**ADDENDUM NO. 8 TO PROJECT NO. 44808**

**CONSTRUCTION WORK, HVAC WORK, PLUMBING WORK, AND ELECTRICAL WORK  
RENOVATE BUILDING NO. 5  
STATE OFFICE BUILDING CAMPUS  
1220 WASHINGTON AVENUE  
ALBANY, NY**

January 14, 2014

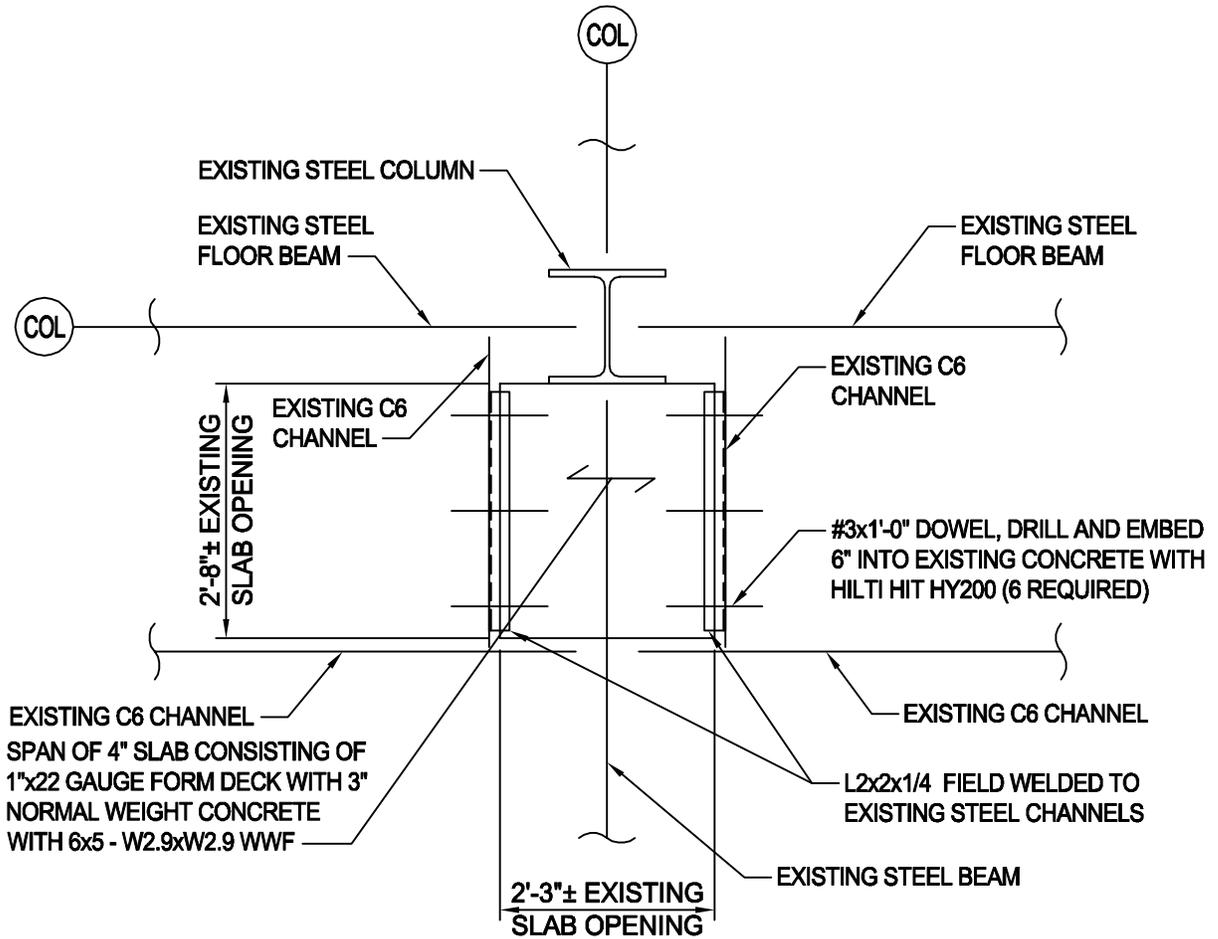
14. Addendum Drawings:
- a. Drawing Nos. S-504, S-505, and S-506 noted “ADDENDUM DRAWING 1/10/14” accompany this Addendum and form part of the Contract Documents.

- 1) NOTES: Add the following Note to each of these drawings:
      3. Provide 3 hour fireproofing at underside of deck infills. Typical at all conditions shown”.
